## Peer Review Report B

**INDEPENDENT PEER REVIEW – REPORT B**  
Viva Energy Gas Terminal Project  
Supplementary environment effects statement

05 August 2024

Prepared for:  
Department of Transport and Planning

Figure 3-17. Comparison of Cover in Intertidal Discharge and Reference Zones

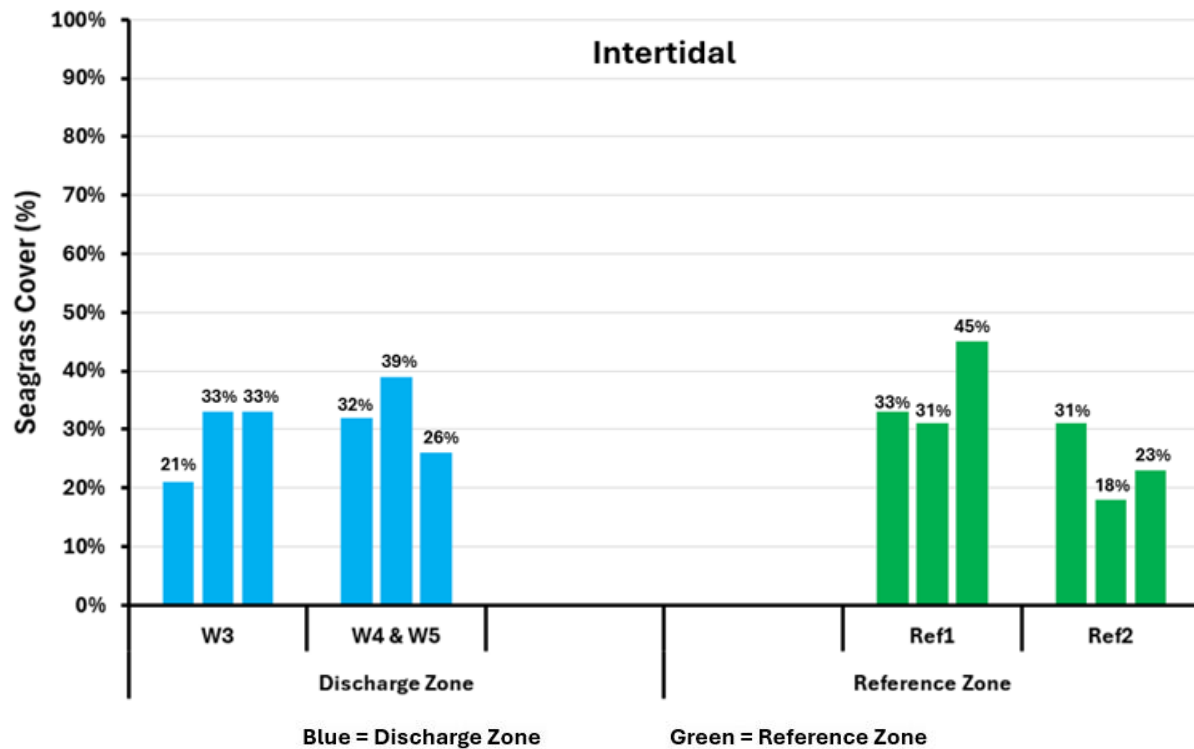
76		PDF page 165, Table 10.1	Are confidence limits available for NTU and PAR?, if so, please include	2	Closed - no change made.	NTU and PAR are variable over time - as illustrated in Figure 9-5. It is not considered necessary to include confidence limits.	76	24/06/2024	V2 - Chapter 10	10.4, p 10-84, Table 10.1	Response does not answer the reviewer's question. And, who considers it unnecessary to include estimates of variability around means if available? I don't accept that at all. First, if the values provided in Table 10-1 are indeed averages, then this must be clearly worded in the table caption (e.g., Previous Average Turbidity and Light Attenuation Measurements for Corio Bay, or similar). Second, if the source (Provis 2009) calculated estimates of variability associated with those averages and they are available in that source material, they should be included with the averages in Table 10-1. Third, if the averages in Table 10-1 have been calculated by the authors of this current report, then calculated measures of variability should be included. Finally, if the source data are averages only (with no associated measures of variability), then the reviewer's comment could have been responded to by simply stating that confidence limits or standard errors were not available.

Figure 3-17 shows the data for the intertidal seagrass cover measured in the discharge zone (blue columns) and the intertidal seagrass cover measured in the reference zone (green columns). Although there was variability from month to month, the average seagrass cover in the discharge zone of 31 % over the measurement period was about the same as the average seagrass cover in the reference zone of 30 %.

The two-sided t-test is used to determine whether there is a significant difference between the seagrass cover in the two zones. The 6 cover measurements in the discharge zone (Mean = 31, SD = 6.3) were compared to the 6 cover measurements in the reference zone (Mean = 30, SD = 9.3). The two-sided t value is 0.11. The p-value is 0.92. Degrees of freedom = 10. The difference in seagrass cover is not significant at  $p < .05$ .

**Figure 4-8. Comparison of Measured and Modelled Currents**

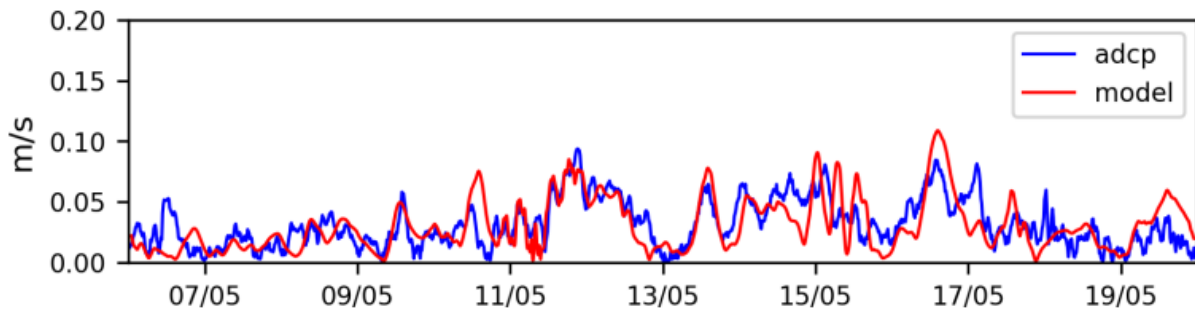
9		V2	Section 4.6.2	Figure 4-7 and accompanying text should be included in this section to make the grid extents clear.	24/06/2024	3						
10		V2	Fig 4-6	axes should be labelled as modelled and measured.	24/06/2024	4						
11		V2	Section 4.7.1	A time-series comparison of measured and modelled currents would demonstrate the correct representation of the tidal and wind-driven flows. The lack of such comparison is concerning. The statements in para 3 require some evidence.	24/06/2024	4

A time series comparison of predicted and measured current speeds for was already in the supplementary marine studies report (Figure 4-8). The reviewers must have missed seeing it. The model reproduced the measured current speeds and direction well (and is reproduced on the following page).

As an example, a time series comparison of measured and modelled currents is provided in Figure 4-8. The refined model reproduces the measured current speeds and direction from the winter 2021 ADCP deployment to a satisfactory degree.

**Figure 4-2. Comparison of Predicted and Measured Current Speeds**

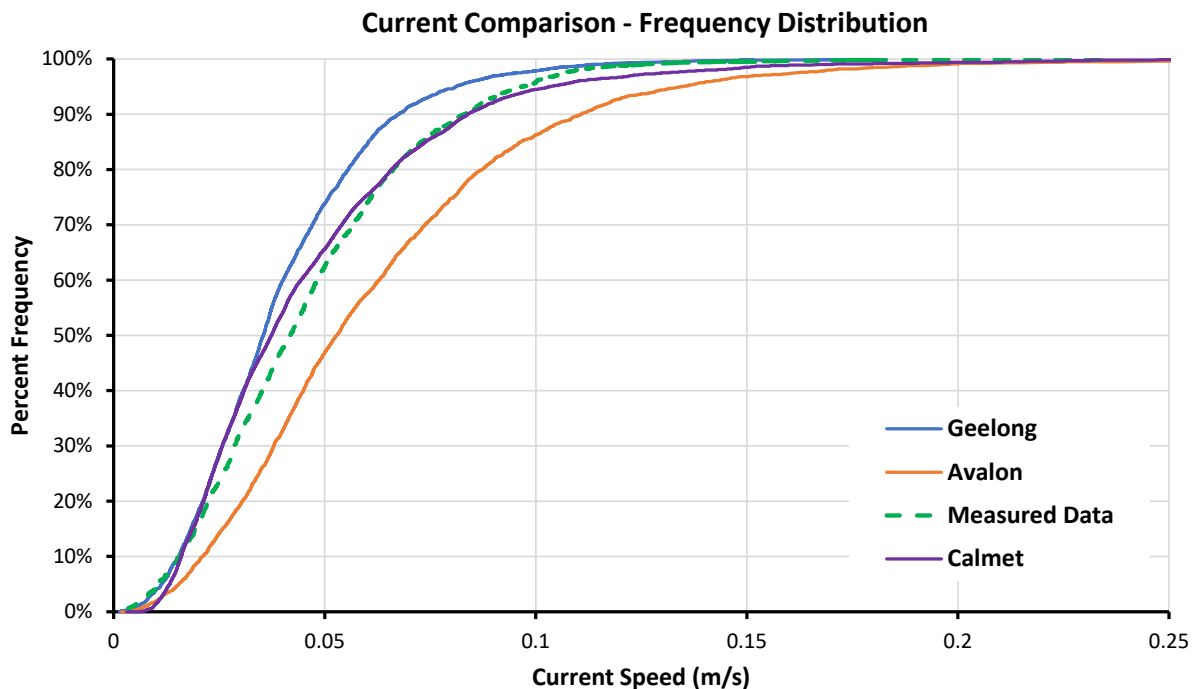
5		V2	Section 4.5.1, para 5, last sentence.	First mention of Calmet - no context - not meaningful.	24/06/2024	3						
6		V2	Figure 4-3	Figures 4-2 and 4-3 are intended to demonstrate the difference in model results using differing wind fields. Since (as I understand it) the chlorine concentrations are derived from a relationship to the water temperature, in this context, Figure 4-3 provides no new information not already included in Figure 4-2 .	24/06/2024	2						
7		V2	Section 4.5.4, first para	It is implied that Figure 4-5, a plot of plumes, was used to conclude that Calmet (note typo in text) is the most representative. This figure does not provide that information and a side by side of measured and modelled would be useful.	24/06/2024	3						
8		V2	Fig 4-5	What is the time basis for this plot - is it an average over some time, or a specific time. Without this information, it is not meaningful.	24/06/2024	3

Figure 4-2 compares the predicted current speed distributions using the three wind files with the measured current speeds (dashed green line) for the northern current meter location. The currents predicted using Calmet winds (purple line) show the best fit to the measured current speeds. The currents predicted using the Geelong winds (blue line) are similar to those for the Calmet winds in the lower half of the range, but slower than the measurements from 3 to 11 cm/s. The currents predicted using the Avalon winds (orange line) result in current speeds substantially higher than the measured currents.

Note that the difference between the predicted currents and measured currents using the Calmet wind file are within 0.01 m/s of the measured currents – which is within the accuracy of the measurement of the current meter of +/-0.01 m/s.

Figure 4-11. Measured Plume Temperature Contours – July 2023 to Jan 2024

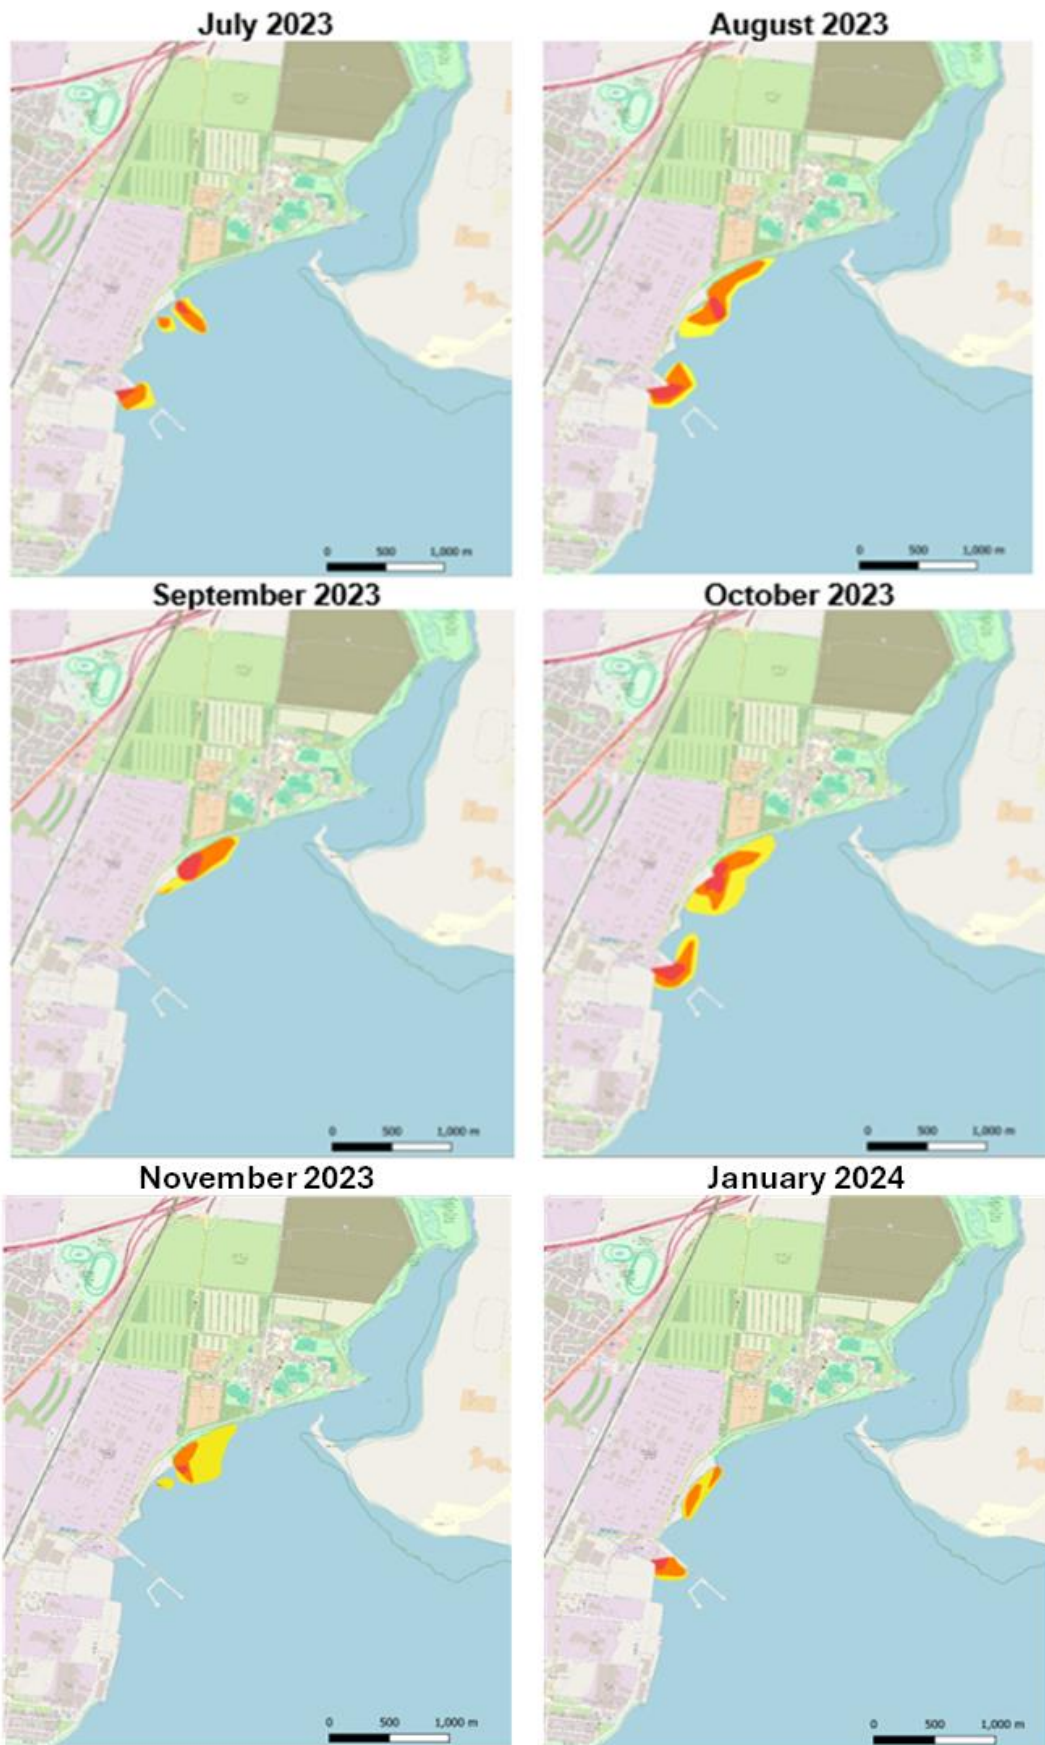
16	V2	Fig 13	Given that the chlorine values are inferred from temperatures and that Fig -11 and 4-12 show a range of temperature plumes, which one was selected for Fig 4-13 - why? Very specific statements are made about plume extent, while the evidence from the temperature is that there is a range of temperature plumes.	24/06/2024	4							
17	V2	Figure 4-14 and 4-15	What is the reason for using a 4 hour average for the current vectors. If it is intended to remove tides, then a 12 hour average would be relevant. Four hours would seem to only include part of the tidal cycle.	24/06/2024	4							
18	V2	Section 4.10	The peer review has been undertaken, but is not complete. The editing of this section includes significant changes. Have these changes been included in a revised report on the modelling? Such a report has not been separately reviewed.	24/06/2024	4

Figure 4-11 shows the 2023 temperature measurements in the existing plumes and Figure 4-12 shows the thermal plumes simulated by the model under comparable conditions. Both were generated with the same tide and wind conditions in the model as during the day of field measurements. Plumes were measured as described in Section 3.4.

The comparison of the sets of images illustrate that the model reproduces plumes similar to the observed shape, temperature difference and extent of the plumes along the refinery shoreline.
